Appln No. 10/752,382

Reply to Office action of January 24, 2005

Amendments to the Drawings:

REMARKS/ARGUMENTS

FIG. 6A

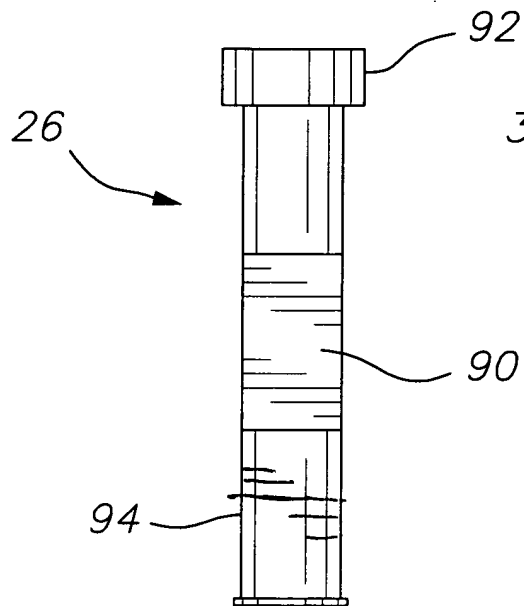
The attached sheet of drawings includes changes to Figs. 6A and 6B. This sheet, which includes Figs. 6A and 6B, replaces the original sheet including Figs. 6A and 6B.

The Examiner has rejected claims 18 and 21 as failing to comply with the enablement requirement. Specifically, the Examiner is unclear how pin 36 could be inserted past portion 38 of the frame. The specification clearly states that the shape of the pin is not critical but rather it should conform to the shape of the openings. See pg. 7, lines 33-35 and pg. 8, lines 3-6. Accordingly, Figs. 6A and 6B have been amended to show a pin that conforms as described. Applicant submits herewith an amended set of drawings showing an amended pin in Figs. 6A and 6B. Accordingly, Applicant respectfully requests that the
